Access Compliance Report Public Rights-of-Way (Curb Ramps)

Main Street: SMOKE_TREE_DR Cross Street: HYDRANGEA_ST Location: SE

ADA ID: RPAT211102151852 Ramp Type: Type 4 - Parallel Initial Pass/Fail: Fail Overall Compliance: No Severity Score: 16

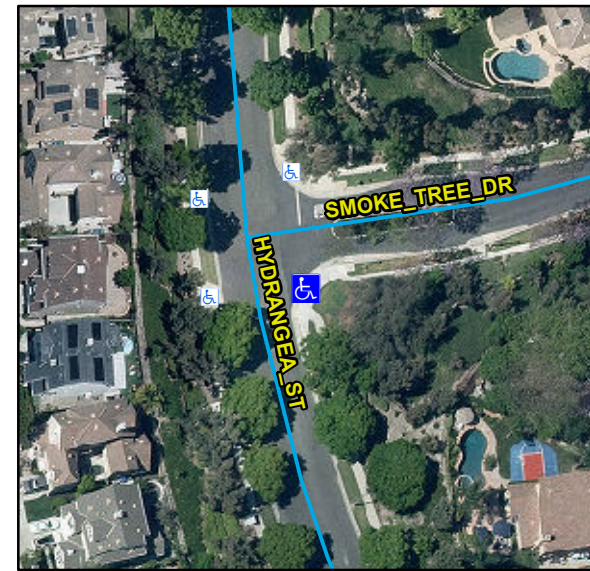
R204.3, R304.3.2, R304.5.3, STD 1115

Compliance	Description	Data	Compliance	Description	Data
N/A	Ramp Length LT (in)	115	N/A	Ramp Length RT (in)	110
Yes	Ramp Width LT (in)	89	Yes	Ramp Width RT (in)	89
Yes	Ramp Run Slope LT (%)	0.1	No	Ramp Run Slope RT (%)	9.1
Yes	Ramp Cross Slope LT (%)	1.6	No	Ramp Cross Slope RT (%)	3.1
N/A	Landing Present	N/A	N/A	DWS Provided	N/A
N/A	Landing Length (in)	N/A	N/A	DWS Contrast	N/A
N/A	Landing Width (in)	N/A	N/A	DWS Length (in)	N/A
N/A	Landing Run Slope (%)	N/A	N/A	DWS Full Width	N/A
N/A	Landing Cross Slope (%)	N/A		DWS Offset Type	N/A
N/A	Landing Movement Obstructed?	N/A	N/A	DWS Offset Left (in)	N/A
	Landing Movement Type	N/A	N/A	DWS Offset Right (in)	N/A
N/A	Landing Shared	N/A			
N/A	Clear Space	Yes			
N/A	Clear Space To Crosswalk (in)	N/A			
N/A	Marked Crosswalk 1	No	N/A	Marked Crosswalk 2	No
	Crossing 1 Direction	N		Crossing 2 Direction	W
	Marked Crosswalk 1 Width (in)	N/A		Marked Crosswalk 2 Width (in)	N/A

Remove & Replace Curb Ramp With Two New Directional Ramps or Equivalent.
